SECTION 18

Revisions to the Draft EIR Text

Introduction to Revisions to the Draft EIR Text

Figure 5.9-4
Characteristics of an Inclined Dense Jet

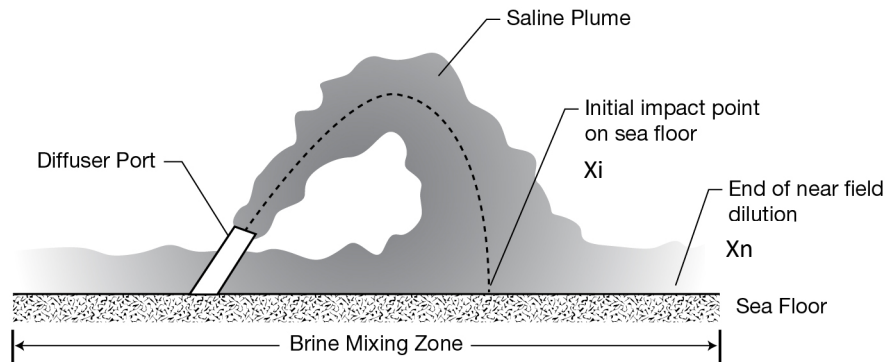
The linear diffuser model analysis (Appendix 4C-14A) demonstrates that operational discharges from the Local Project would not exceed 2 ppt above ambient conditions at the BMZ boundary. In fact, the model analysis indicates that the 2 ppt salinity threshold would be met at a distance of 11.6 m (38 feet) between the point at which the brine plume makes contact with the seafloor (at X_i), and from the point of discharge (Table 5.9-6). Such a distance is well within the 100 meters (328 feet) from the point of discharge as prescribed in the California Ocean Plan and would translate to a circular area of approximately 0.1 acres around the diffuser. The terminal height would reach a maximum

of 19.5 feet above the seafloor for both scenarios and after descending and making contact with the seafloor, the model analysis indicates that the brine plume would continue entraining ambient seawater and further diluting until the plume momentum reaches zero (i.e., the edge of the near field (at X_n); at 119 between 45 and 63 feet (13.7 m to 19.2 m) from the point of discharge (Table 5.9-6) for all scenarios modeled. The salinity at the edge of the near field would decrease to 1.9 be equal to or less than 2 ppt above ambient, well within the distance of 100 meters (328 feet) prescribed in the California Ocean Plan. The total seafloor area from the diffuser to the edge of the near field (at X_n) would be an ~~area~~ circular area of approximately ~~± 0.3 and 0.5~~ acres (Appendix 4C14A). Thus, brine discharges from the Local Project would not exceed or violate the California Ocean Plan salinity standards or degrade water quality in terms of salinity; impacts related to salinity would be less than significant.
